Smart Motorways Programme

M4 Junctions 3 to 12 Smart Motorway

Non-Material Change
Wood Lane Overbridge
Technical Note

Document Number: HA514451-CHHJ-GEN-SZ_ZZZZZZZZ_Z-TN-KK-0050

Figure 2 2021 NMC Design of Wood Lane overbridge side road

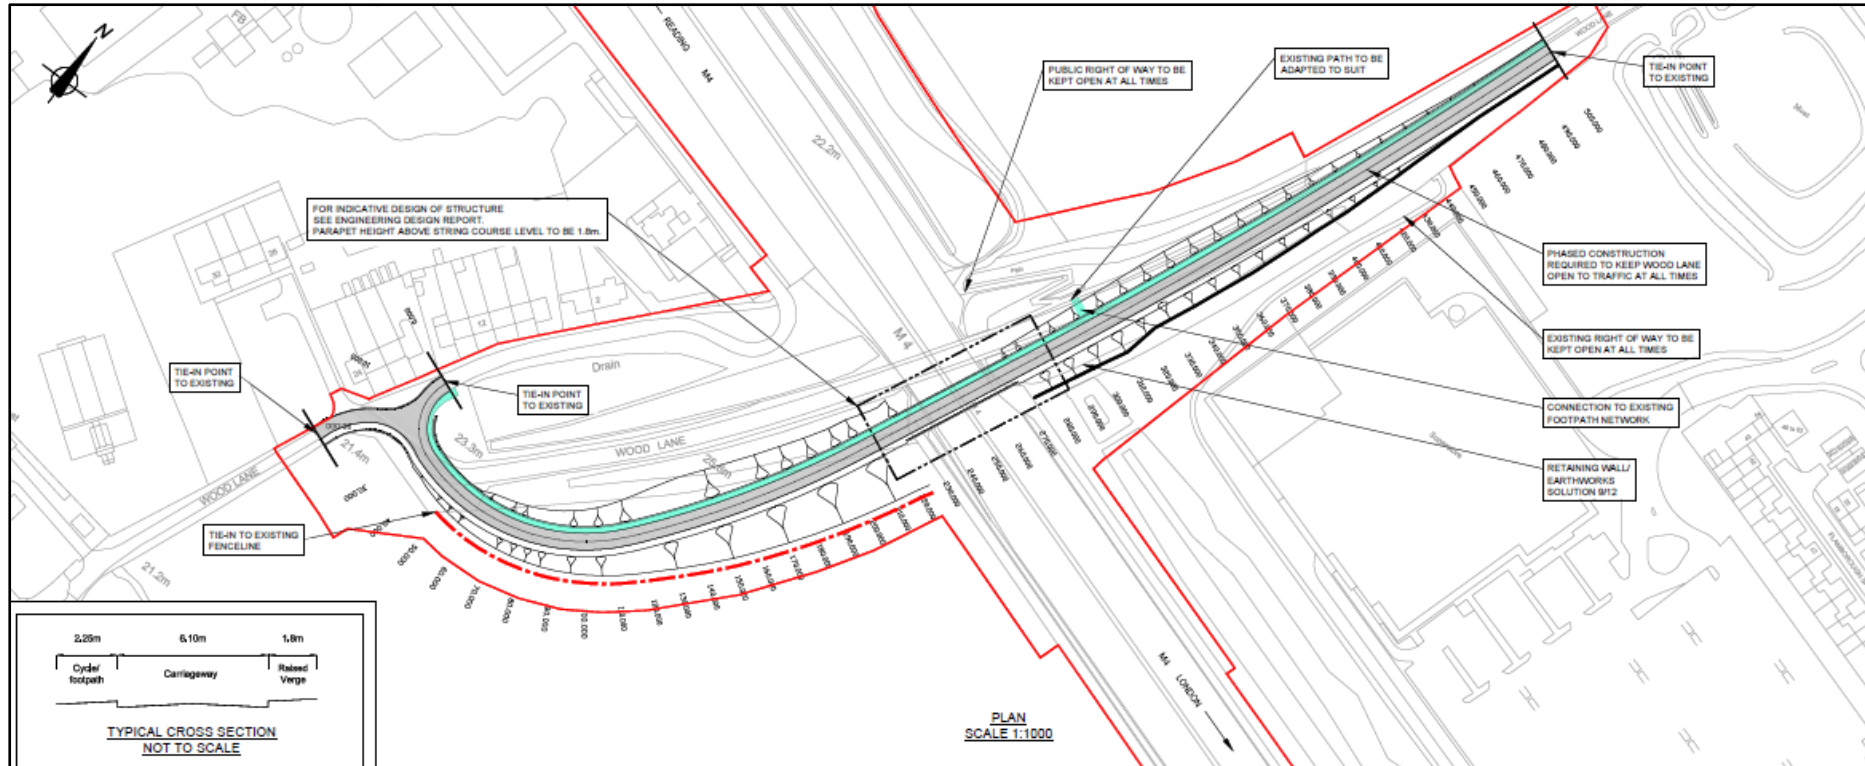
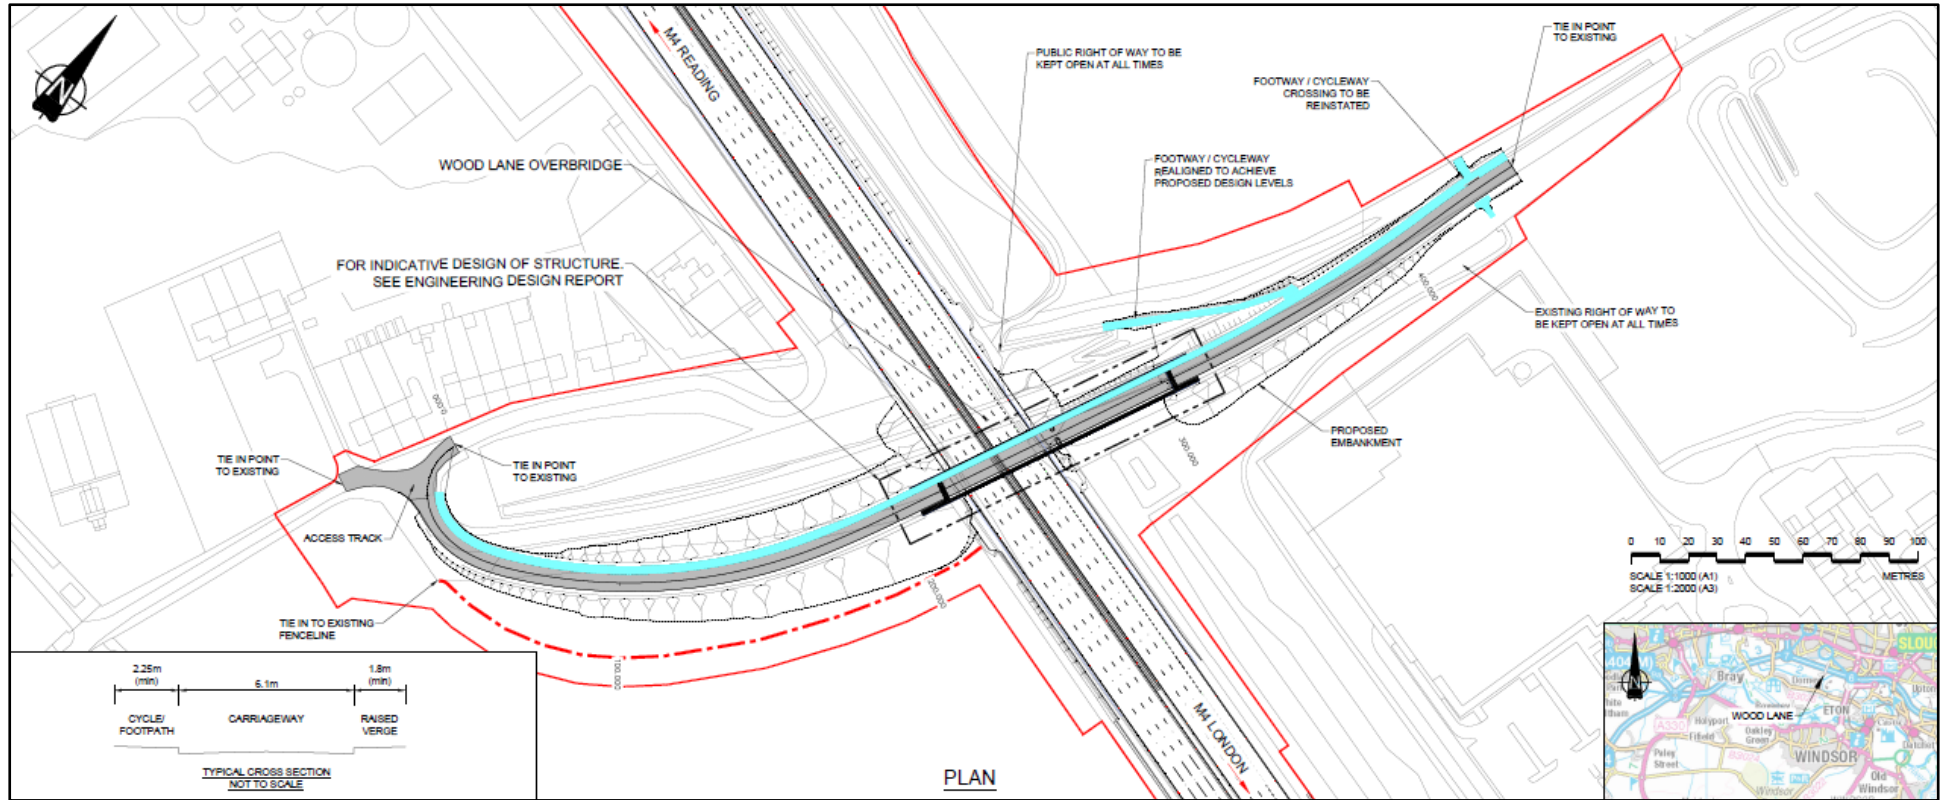
The current proposed design of Wood Lane overbridge is shown in Figure 2. The engineering solution taken forward is an offline constructed (as per previous design) semi-integral two-span steel composite structure, providing a back-span to the bridge on the north side of the mainline. The proposed deck comprises two unequal spans, measuring 43.5m and 45m in length for the southern and northern spans, respectively. The two-span solution allows the bridge deck to span over the Thames Water Main and two 750mm diameter sewer pipes, mitigating the 6-month delay identified. Additionally, the footpath/cycleway to the northwest has been realigned to suit the extended overbridge.

This change has resulted the change in height 284mm outside of the DCO limit of deviation.

The abutments are supported by contiguous piles, increasing the number of piles previously featured in 2015 DCO Design. To the north of the mainline, the mid-span is rested on two pier columns founded on a pile cap which is supported by number of individual piles. Steel sheet piles are placed between the piles supporting the piers and Thames Water Main in order to protect the piles in the event where water main is damaged. The two-span structure also comprises contiguous piled wingwalls to the rear of both south and north abutments, which have been stabilised by a number of tie rods. There are five tie rods used between the south wingwalls and three for the north wingwalls.

The minimum earth cover required on top of the Thames Water main and the two sewer pipes has resulted in a section of the earthworks situated under the northern span to be close to the soffit of two girders to the west, where minimum clearance could be as low as 500mm. Nevertheless, the earthworks profile is modified to allow for inspection/maintenance of the north abutment shelf.

The vertical retaining wall, featured in the 2015 DCO Design, on the north-eastern side of the new bridge has been removed, thus allowing earth embankment construction which can be planted to provide visual screening.

The vertical profile of Wood Lane has been amended to suit a reduced design speed of 50kph. As a result, the earthworks on the approach to the south of Wood Lane overbridge are lower, but the height of the bridge has increased by 784mm. This change in vertical alignment is outside the limits of deviation set out in the (DCO) and therefore these changes are included within the Non-Material Change Application.
